## **ZONING CHANGE REVIEW SHEET**

**CASE:** C814-06-0233 – Wildflower Commons  
Planned Unit Development

**ADDRESS:** 4700 – 5200 Block of SH 45

EXHIBIT B  
AND USE PLAN

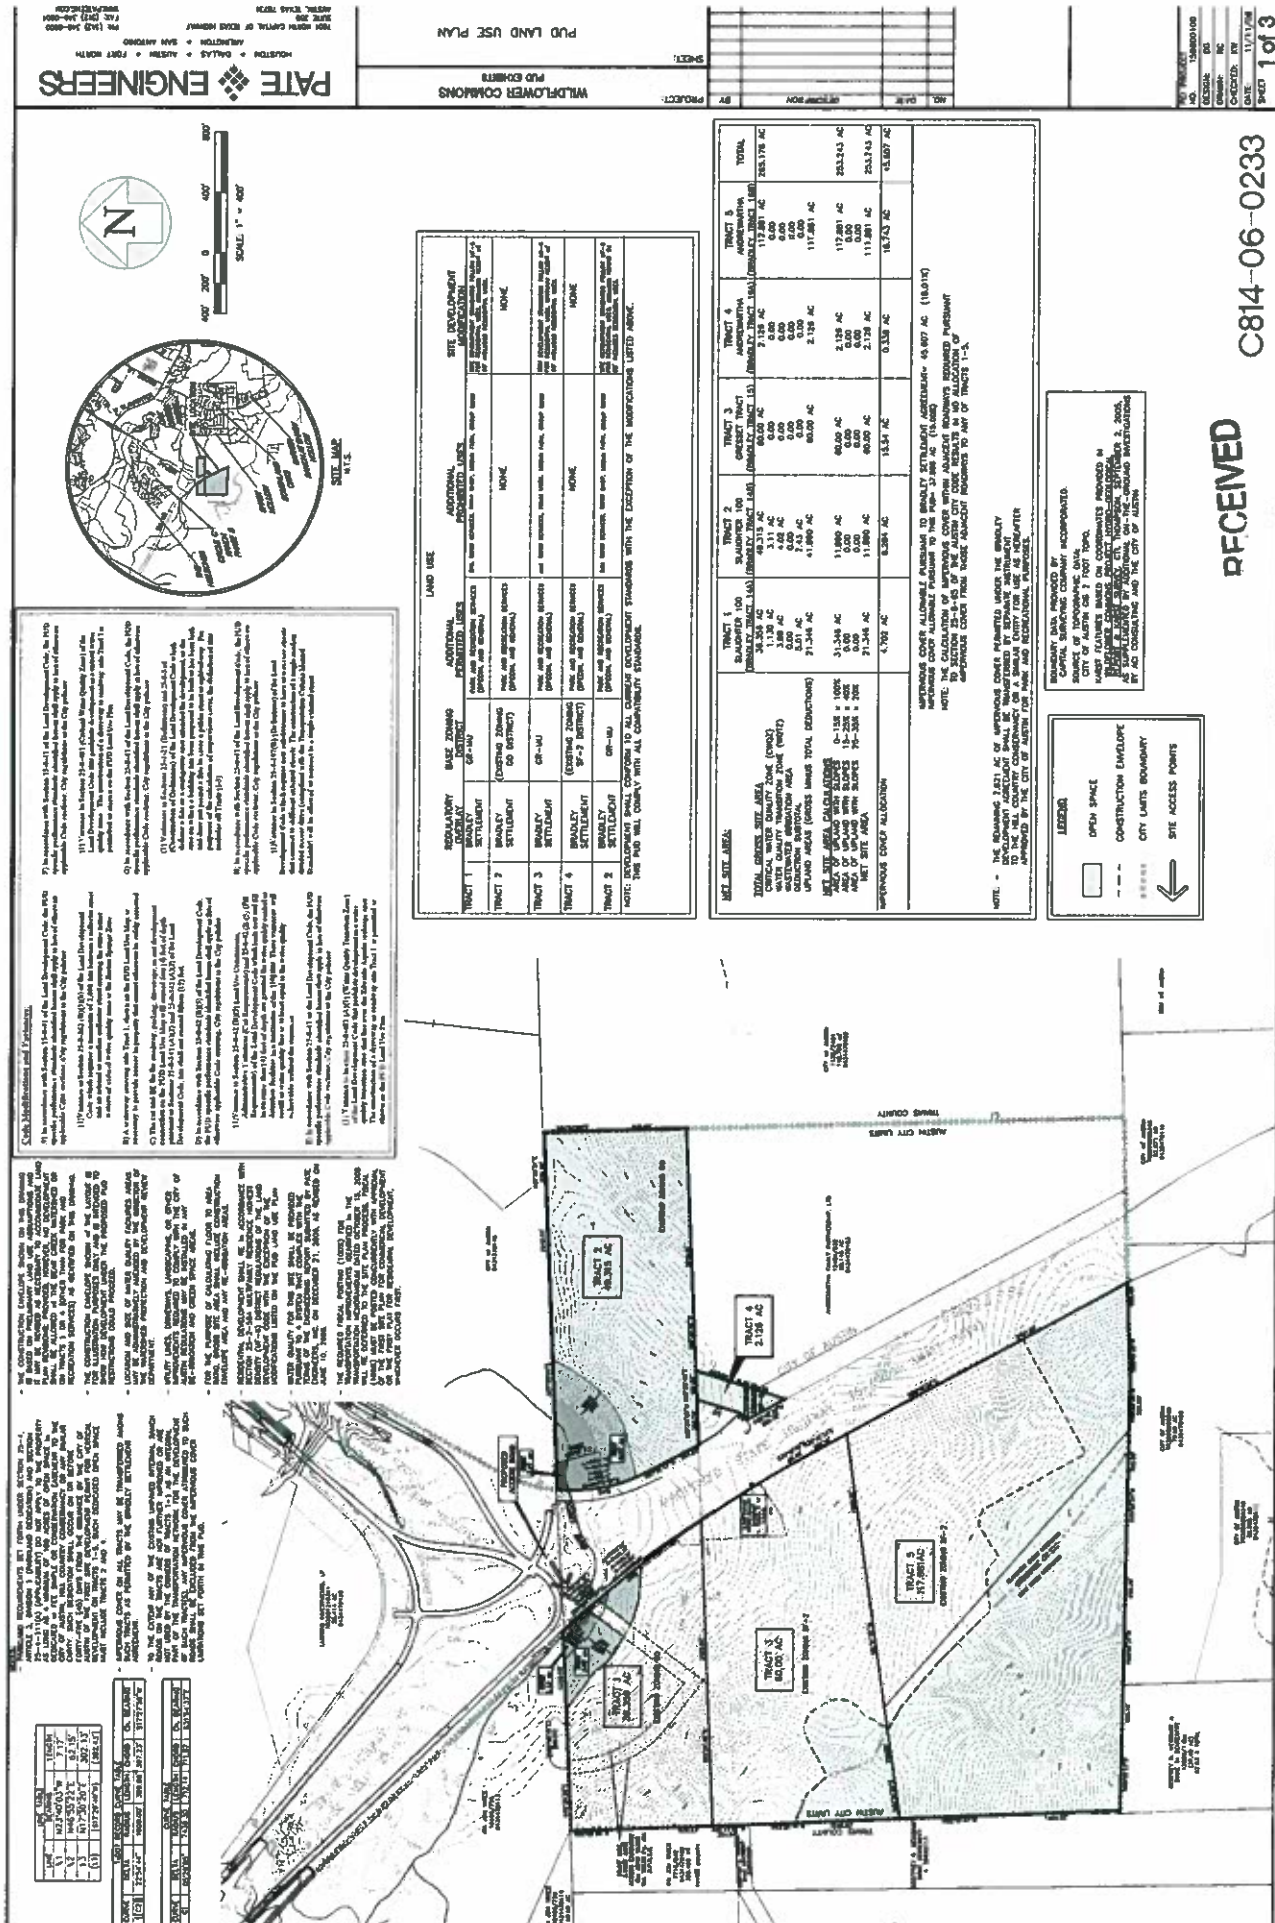
4. **Adjacent Roadway Impervious Cover.** The PUD Land Use Plan (Exhibit B) contains a note: "NOTE: PURSUANT TO THE TERMS OF THE LAND DEVELOPMENT CODE, THE IMPERVIOUS COVER PROPOSED (37.988 ACRES) FOR TRACTS 1-5 SHALL NOT BE SUBJECT TO ANY ALLOCATION OF IMPERVIOUS COVER FROM ANY ADJACENT ROADWAY."

This note should be removed from the land use plan. Applicant is required to follow the Bradley Agreement and the Land Development Code. Impervious cover must be calculated in accordance with those standards and this note prevents any perimeter or

adjacent roads in the future when site plans are filed for these tracts from being calculated as they should be under law.

1. Provide screening along proposed SH 45 outside Texas Department of Transportation right-of-way on the west side along the construction envelope.
2. Remove secondary access PUD note Remove PUD note regarding additional permitted land uses, cocktail lounge, liquor sales, convalescent services.
3. Delete exception to LDC 25-8-65 (Roadways) to not account for roadway deduction.

**Map 1: Location Map for Critical Environmental Feature Setbacks  
(Revised - 07-07-2008)**

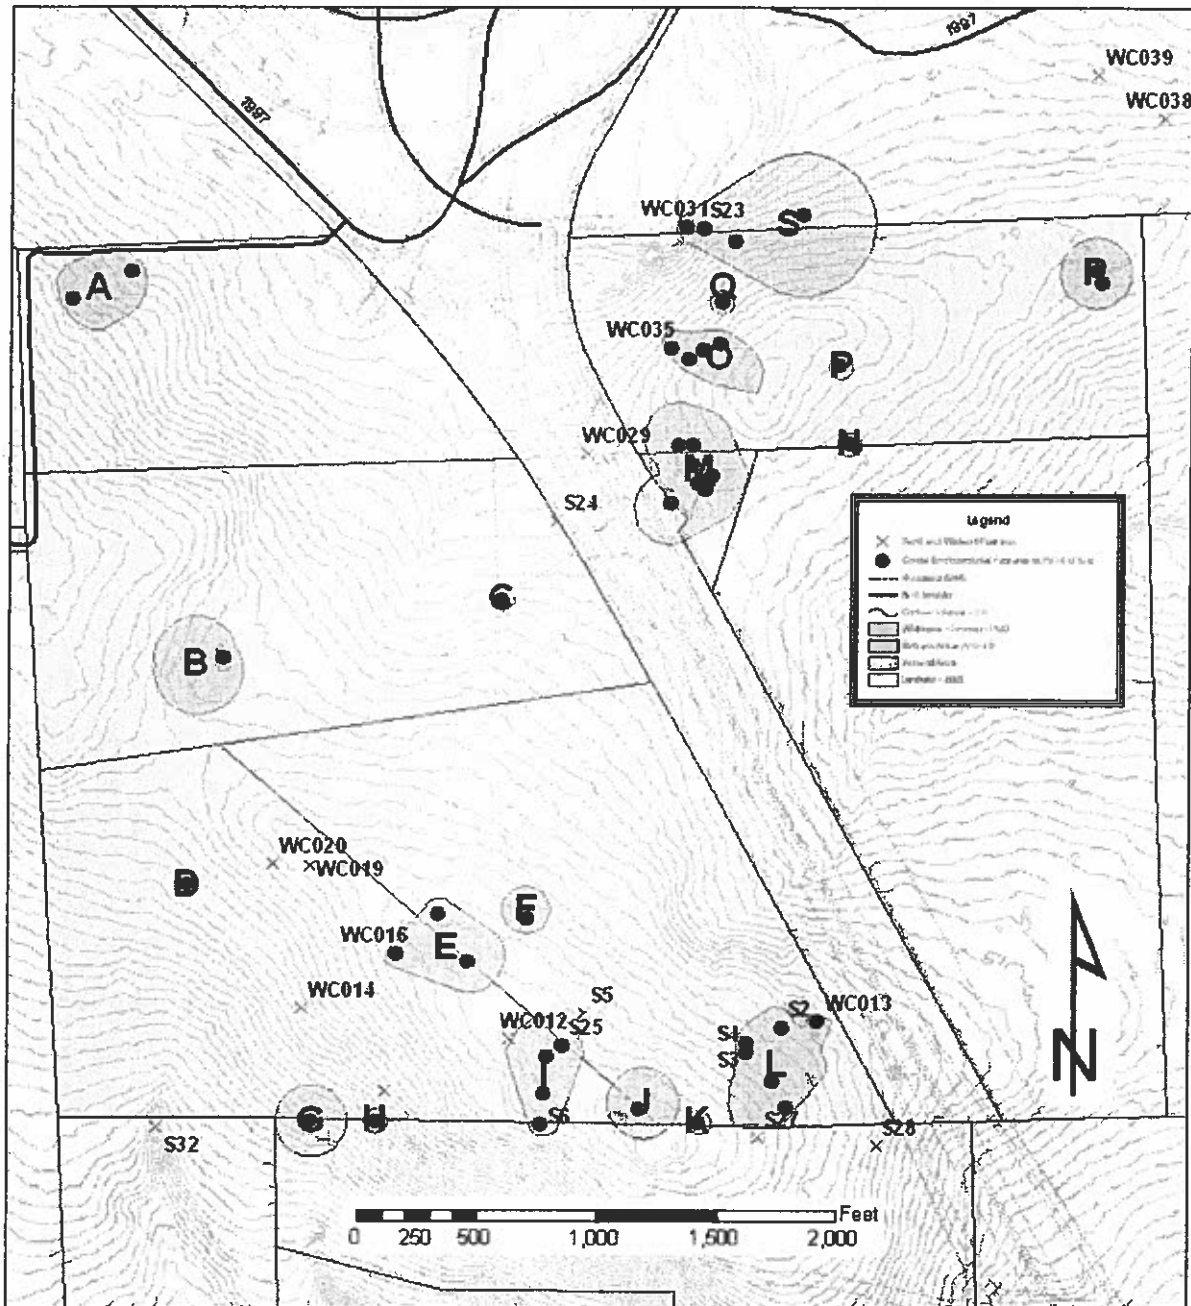
1. No residential lots may include a CEF or be located within 50 feet of a CEF.
2. Setback areas must be established to protect all CEFs. Although the LDC allows a portion of the CEF buffer to be included in a residential lot, I do not recommend that this be allowed. Residential lots should not include any portion of a CEF buffer. Setbacks must comply with the setback area has stated in Table 1 and shown Map 1. ERM is willing to revise setback areas listed in Table 1 and shown on Map 1 during PUD process, if the applicant provides more detail information to ERM staff such as 1-ft topographic survey that better delineates the catchment areas and a hydrogeologic assessment the features that better evaluates it recharge potential.

2. All CEFs and associated CEF buffers are to be shown on all plats, preliminary plans, site plans and construction plans. The PUD ordinance and the plat notes must have a following statement "all activities within the critical environmental feature setback must comply with Section 25-8-281(c)(2) of Austin's Land Development Code. This section states that the natural vegetative cover must be retained to the maximum extent practicable; construction is prohibited; and wastewater disposal or irrigation is prohibited this requirement."

5. Fencing at the edge of CEF buffers must be installed prior to the initiation of construction.
6. Water quality BMPs should not drain directly into CEF setback area. Level spreaders or similar structures must be used to overland sheet flow stormwater before it discharges near CEF setback areas. Stormwater irrigation must occur outside the CEF setback areas.
